# Groundwater Transfer Review Summary Form

Transfer/PA # T- 13037 (re-review)

Application: T-13037 (re-review)

Applicant Name: Weyerhaeuser NR Company

# T-13037 Weyerhaeuser (re-review)

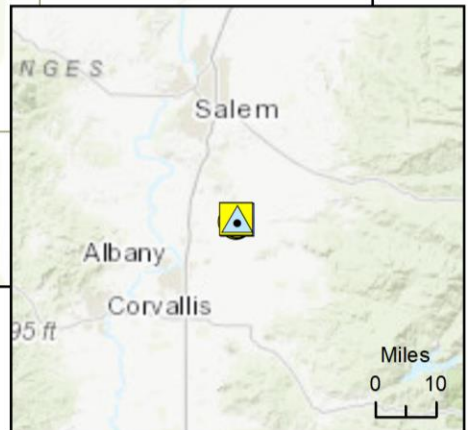
**Certificate 49070, additional POA:** compared to the location of authorized POA MARI 16018 (“Greenhouse Well”), the location of proposed APOA MARI 16020 (“Shop Well”) is perhaps ~850 feet nearer to a likely domestic well at a residence to the west. However, given the very small maximum allowed rate of use (0.03 cfs, ~13.5 gpm), it is unlikely that this proposed use will cause adverse interference in that or other domestic wells in the area: **NO.**

**Certificate 49071, additional POA:** compared to the locations of authorized POAs MARI 16010 (“Well 1”) and MARI 16018 (“Greenhouse Well”), the location of proposed APOA MARI 16020 (“Shop Well”) is perhaps ~800 feet nearer to a likely domestic well at a residence to the west. Given the maximum authorized rate of use (0.66 cfs, ~296 gpm), this proposed use will likely result in increased interference at that presumed domestic well location: **YES.**

**Certificate 49070, additional POA and Certificate 49071, additional POA:** compared to the locations of authorized POA MARI 16010 and MARI 16018, the proposed APOA MARI 16020 is about 800 ft farther from the North Santiam River, and thus no additional interference is likely.

**This drawdown analysis: authorized POA (MARI 16010) to nearest likely domestic well (~1275 ft)**

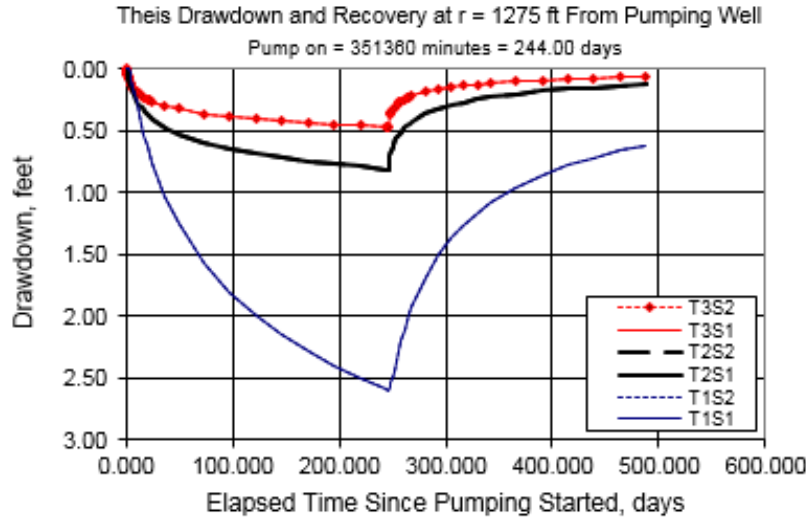
Yes  No If yes, explain: **Certificate 49071, additional POA:** drawdown estimates made using the Theis distance-drawdown relationship indicate that up to about 2 ft of additional interference drawdown might be expected at a domestic well presumably located at a rural residence to the west. It is unlikely that this amount of additional drawdown will prevent this and other nearby groundwater rights from receiving water to which they are legally entitled.
